## DEPARTMENT OF PLANNING AND DEVELOPMENT

**DATE:** July 19, 2024

**SUBJECT:** Consistency Request  
Special Permit #388-21 to allow four single family attached dwellings with dimensional waivers

### *Patio*

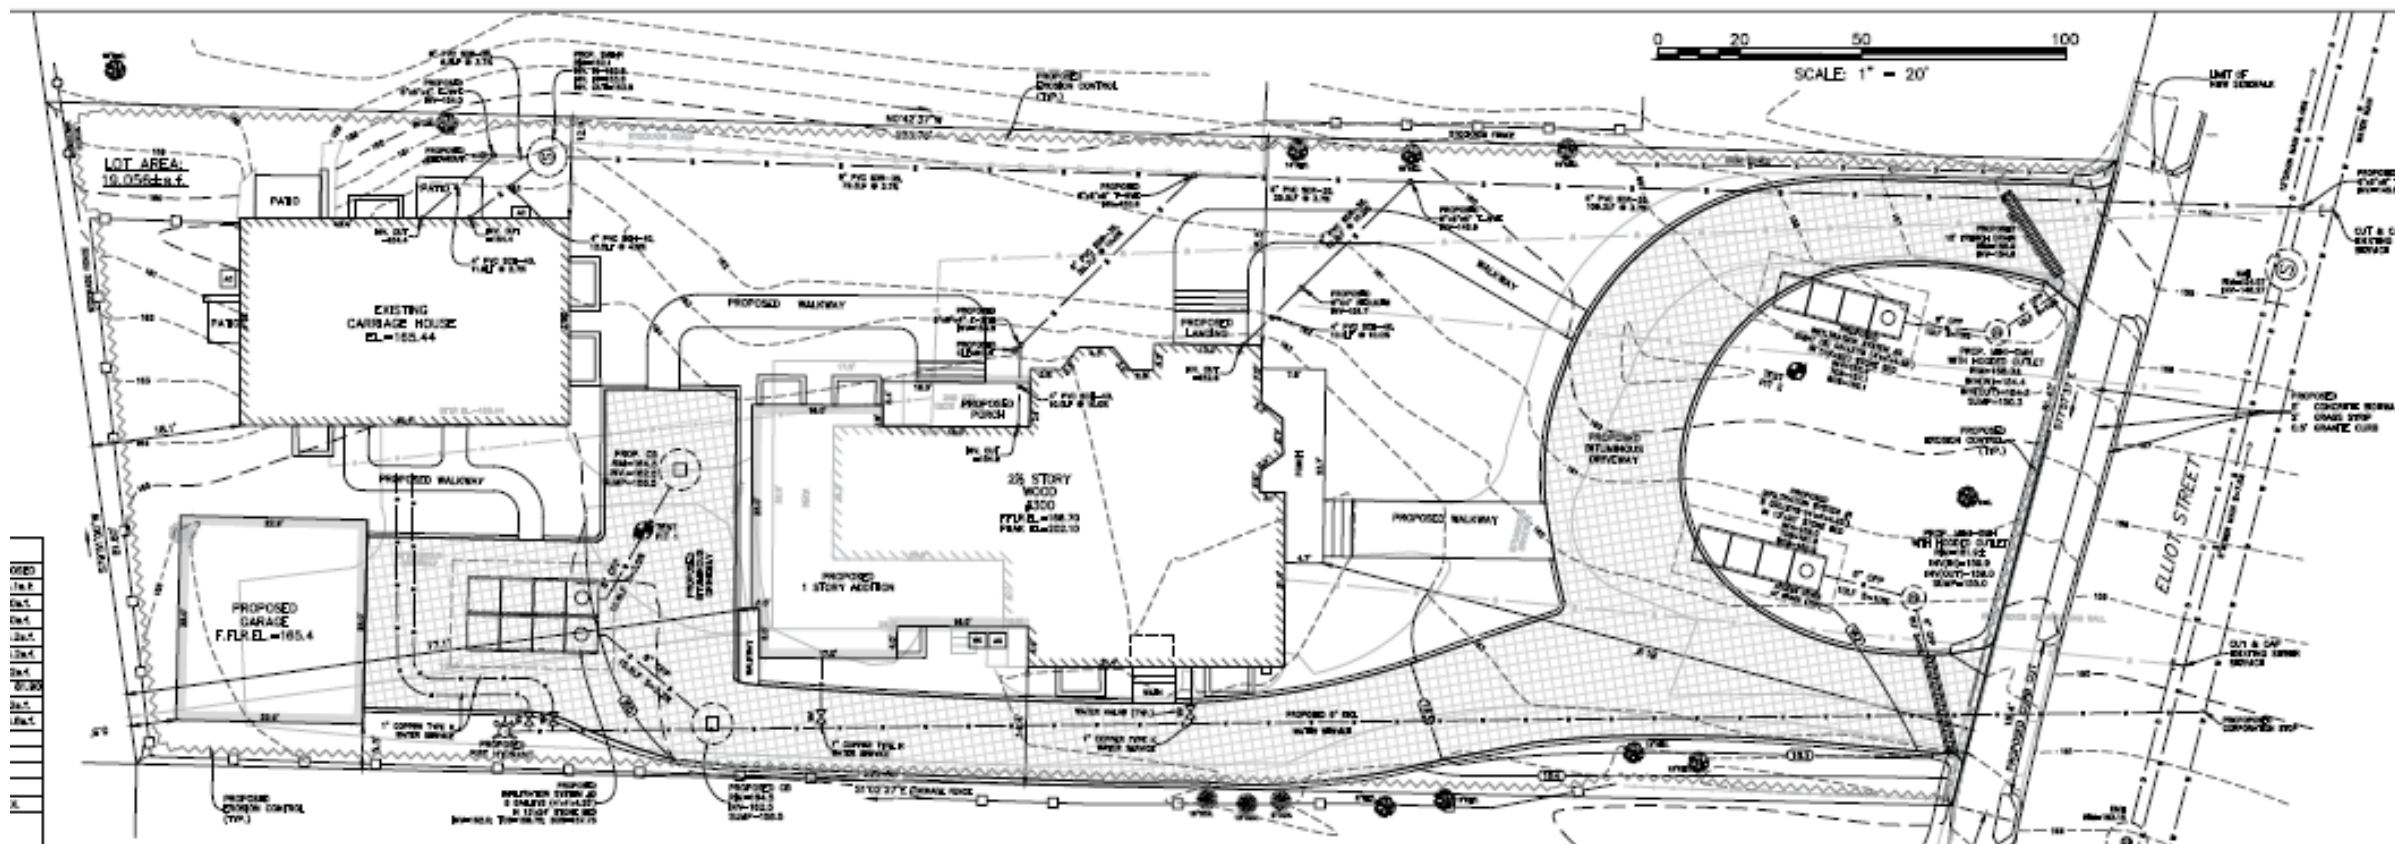
A patio was constructed along the western side yard. On its own, a patio is generally not a cause for concern with the Planning Department as they are allowed as of right per the zoning and it is not unusual that they are considered later in the construction process. However, due to the cumulative changes of the site, it is best handled by consistency. The patio is subject to the Upper Falls Historic Commission review and approval, however, they have yet to apply to the Upper Falls Historic District Commission for approval of the patio.

# Comparison - Rear of the Lot

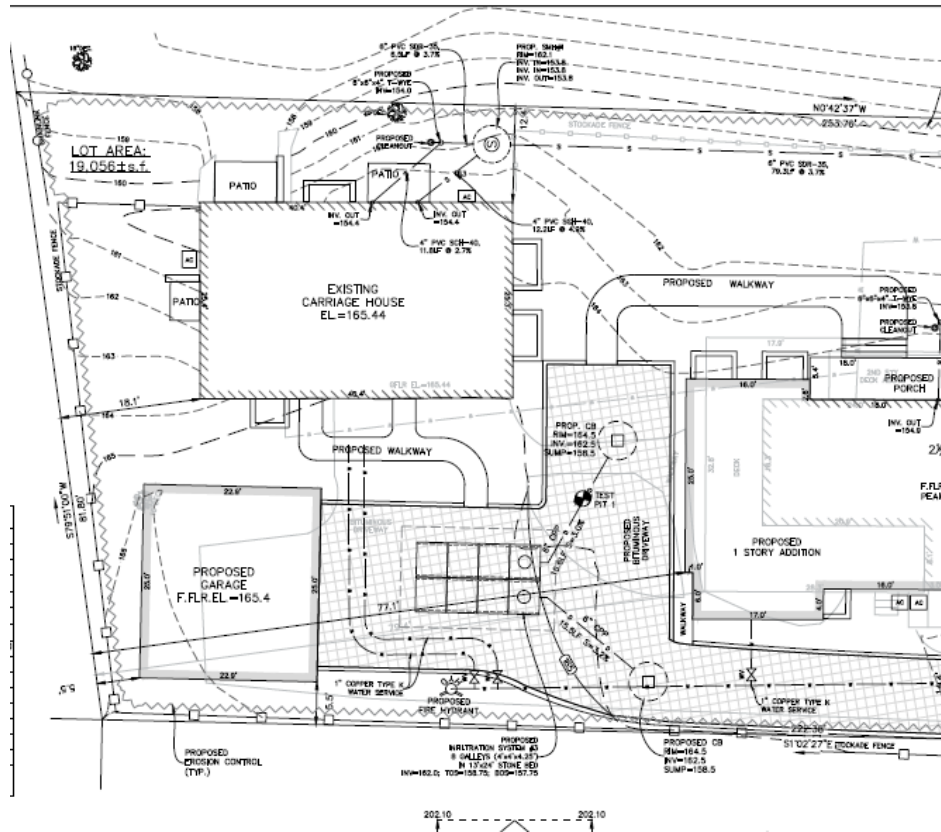
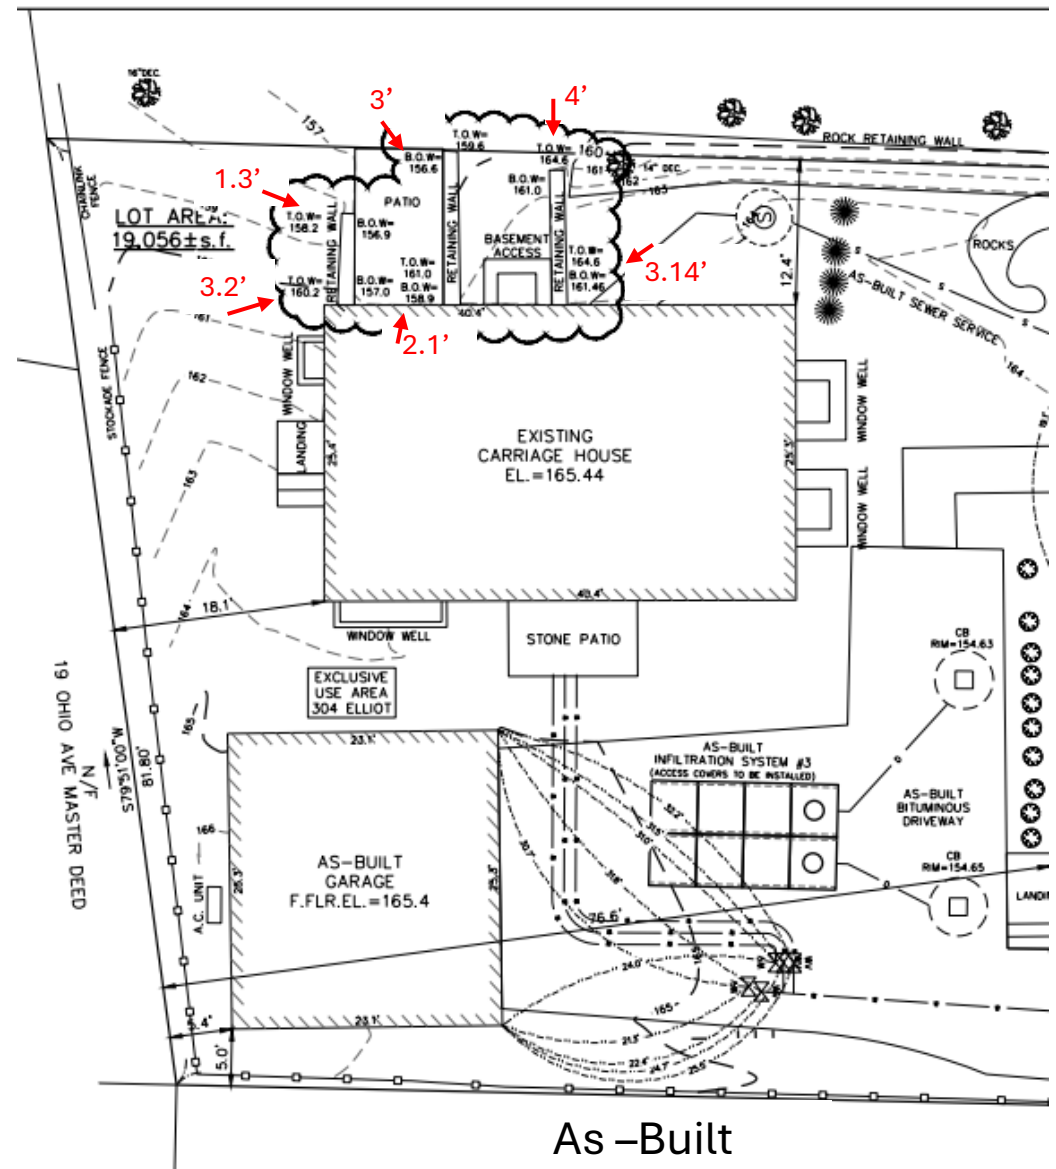
The most drastic change to the site is the construction of retaining walls that were not initially on the approved special permit or building permit plans. Three walls perpendicular to the carriage house were constructed that do not match the approved configuration of one undimensioned wall perpendicular to the carriage house. The as built northernmost wall reaches a height of four feet, with the two walls ranging in height from 1.3 feet to 3.2 feet. The petitioner stated that the site is not complete yet and the four-foot wall will decrease in height due to fill being brought in and have decided not to pursue an amendment to the special permit that would request relief for retaining walls over four feet. Should the wall remain at four feet, Planning and ISD will not sign off on any further occupancy certificates should the wall requiring zoning relief. The Upper Falls Historic District Commission reviewed the three walls and approved them, however, the Commission required a change in materials used to construct the walls. The petitioner is appealing this decision to the MAPC (Metropolitan Area Planning Council).
